COMMONWEALTH OF KENTUCKY  
BEFORE THE PUBLIC SERVICE COMMISSION

*Electronic* Application of Bluegrass Water Utility )  
Operating Company, LLC for Certificates of ) Case No. 2022-00102  
Convenience and Necessity for Projects at the )  
Herrington Haven Site )

**Bluegrass Water’s Response to Staff’s Initial Request for Information**

**PAA FEED PUMP**

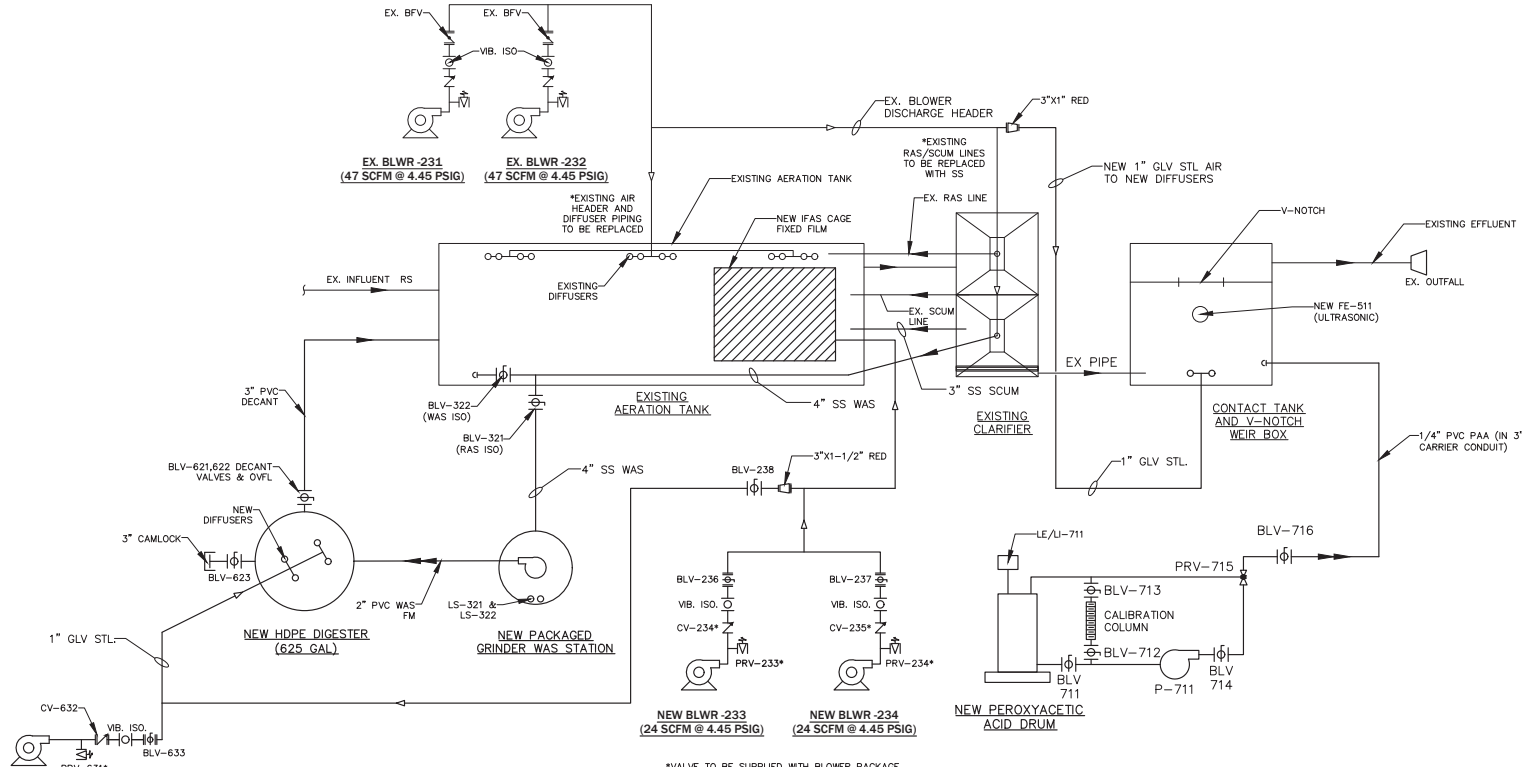
9. Refer to Application, paragraph 12.
    - a. Provide copies of all plans, specifications, drawings, and manufacturer's information sheets pertaining to the peracetic acid disinfection system Bluegrass Water plans to install at the Herrington Haven facility.
    - b. Provide a detailed description of the peracetic acid disinfection system Bluegrass Water plans to install and how it will be integrated into the current systems at the Herrington Haven facility.
-

- a. Please see the attachments, KY2022-00102\_BW\_0001 to 0366, for all plans, specifications, and permit application documents. The peracetic (peroxyacetic) acid disinfection system diagram is noted on page 5 at the lower right portion of the process flow diagram.

**PAA FEED PUMP**

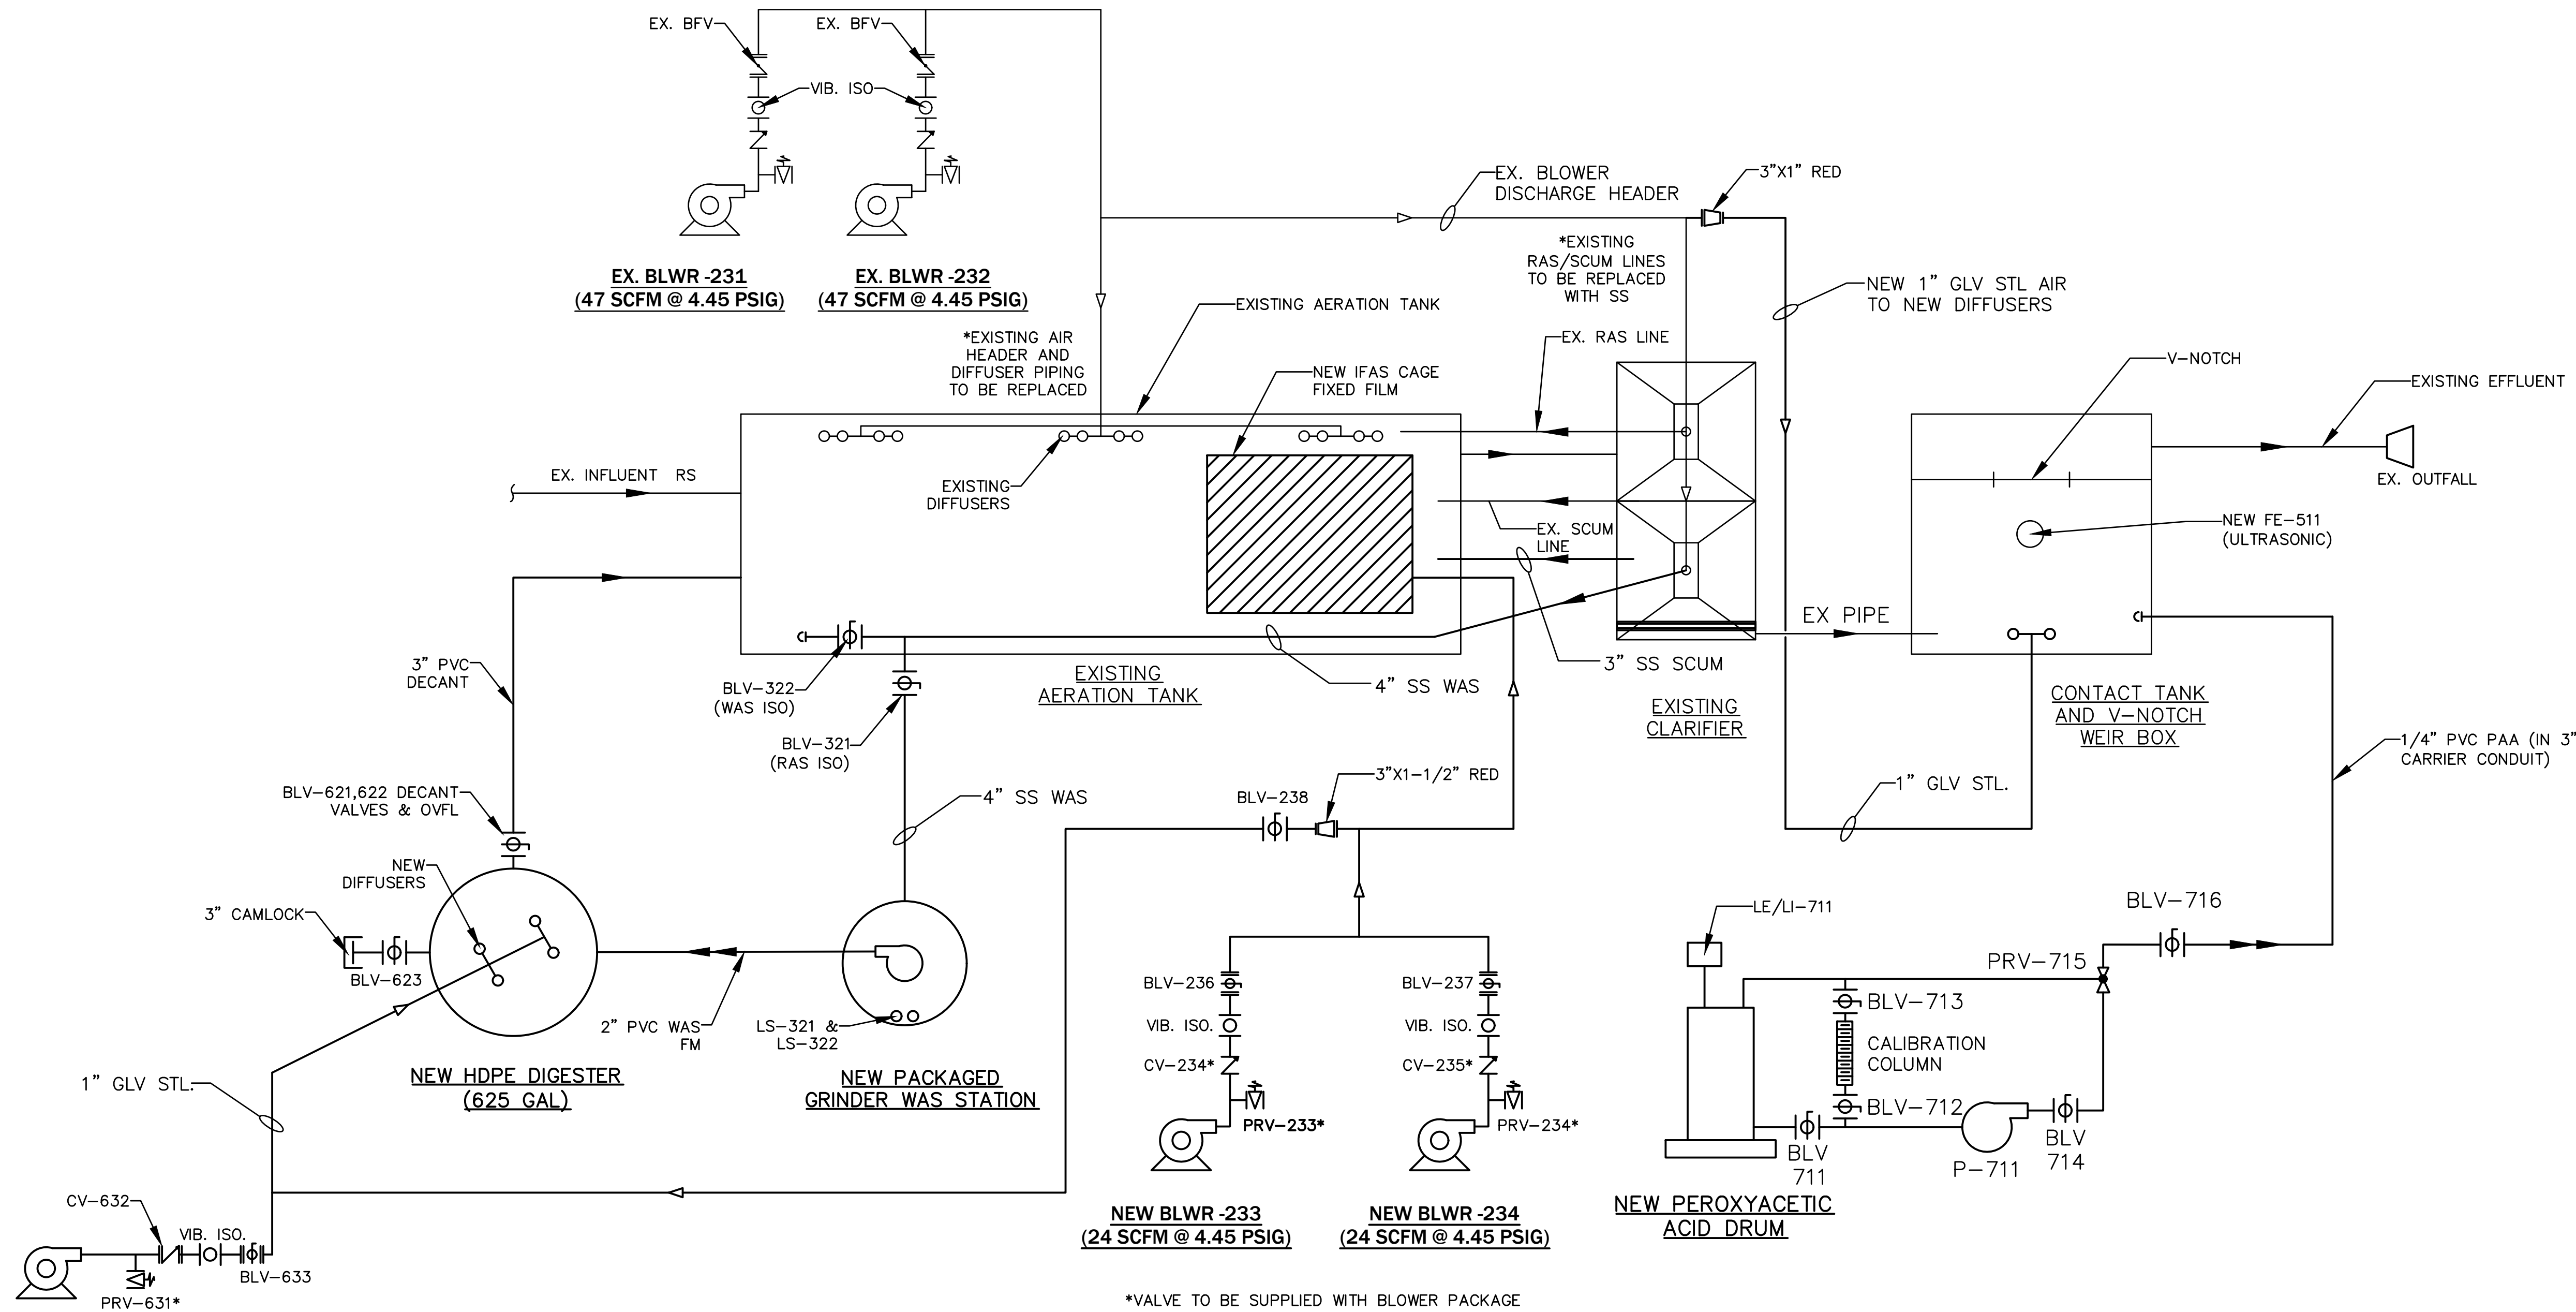
1. Refer to Application, paragraph 10.
    - a. Provide copies of all plans, specifications, drawings, manufacturer's information sheets pertaining to the moving bed biofilm reactor (MBBR) treatment system Bluegrass Water plans to install at the Herrington Haven facility.
    - b. Provide a detailed description of the MBBR treatment system Bluegrass Water plans to install and how it will be integrated into the current systems at the Herrington Haven facility.
-

installation of a single manhole, that manhole had to be devoted to the solids digester. Thus, the MBBR had to be installed as a cage in the existing aeration treatment basin. This can be seen in the document KY2022-00102\_BW\_0371 (attached to the response to 1 PSC 01) which clearly shows the “NEW IFAS CAGE FIXED FILM” within the “Existing Aeration Tank.”
